Access Compliance Report

Public Rights-of-Way

(Curb Ramps)

Intersection ID: 13208	Main Street: W_CATHERINE_ST	Cross Street: WINNIFRED_ST	Location: SE
ADA ID: 23B8AEBD6FEA	Ramp Type: PerpDiag	Initial Pass/Fail: Fail	Overall Compliance: No
			Severity Score: 13.75

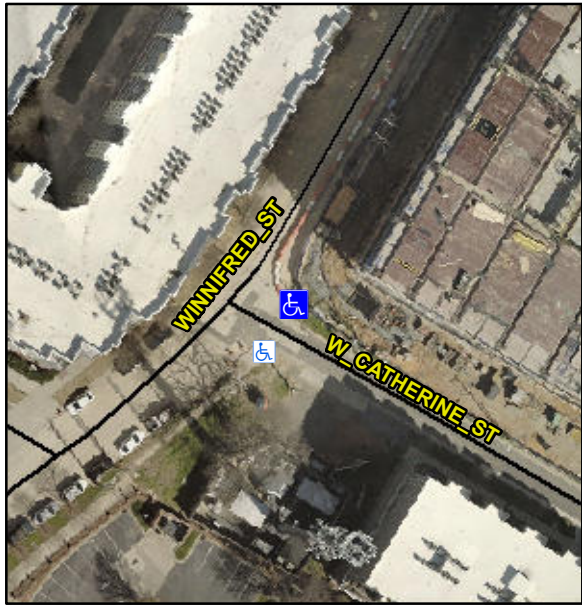
Codes/Mitigation Info/Possible Solution			Field Measurements/Component Compliance					
	Possible Solutions:		Compliance	Description	Data	Compliance	Description	Data
	Remove & Replace Curb Ramp With Two New Directional Ramps or Equivalent.		N/A	Ramp Length (in)	95.0	No	Ramp Slope (%)	8.5
			Yes	Ramp Width (in)	48.0	No	Ramp XSlope (%)	4.0
			N/A	Flare Type LT	N/A	N/A	Flare Type RT	N/A
			N/A	Flare Slope LT (%)	N/A	N/A	Flare Slope RT (%)	N/A
			N/A	Flare Traversable LT?	N/A	N/A	Flare Traversable RT?	N/A
			N/A	Landing Length (in)	N/A	N/A	DWS Provided?	N/A
			N/A	Landing Width (in)	N/A	N/A	DWS Contrast?	N/A
			N/A	Landing Slope (%)	N/A	N/A	DWS Length (in)	N/A
			N/A	Landing X Slope (%)	N/A	N/A	DWS Full Width?	N/A
Surveyor Notes:		N/A	N/A	Landing Curb? (Y/N)	N/A	N/A	DWS Offset (in)	N/A
PROW/ADA:		Not Found, R304.2.2, R304.5.3	N/A	Shared Landing?	N/A			
			N/A	Gutter Ponding?	N/A	N/A	Gutter Slope (%)	N/A
			N/A	Gutter Lip Ht (in)	N/A	N/A	Gutter X Slope (%)	N/A

N/A	Painted X Walk1?	No	N/A	Painted X Walk2?	No
				X Walk 1 Direction	To NE		X Walk 2 Direction	To SE
			N/A	X Walk 1 Width (in)	N/A	N/A	X Walk 2 Width (in)	N/A
				X Walk 1 Slope (%)	2.5		X Walk 2 Slope (%)	3.0
				X Walk 1 X Slope (%)	0.3		X Walk 2 X Slope (%)	4.7
			N/A	Ramp inside XWalk1?	N/A	N/A	Ramp inside XWalk2?	N/A
				Road Slope (%)	1.4	N/A	Clear Space?	N/A
				Road X Slope (%)	4.8	N/A	Clear Space to XWalk (in)	N/A
			N/A	Any Obstructions?	N/A	N/A	Storm Grate/Utility Hazard?	N/A
				Obstruction Type			Storm Grate/Utility Type	
					N/A			N/A
						Yes	Surface Condition? (G/P)	Good
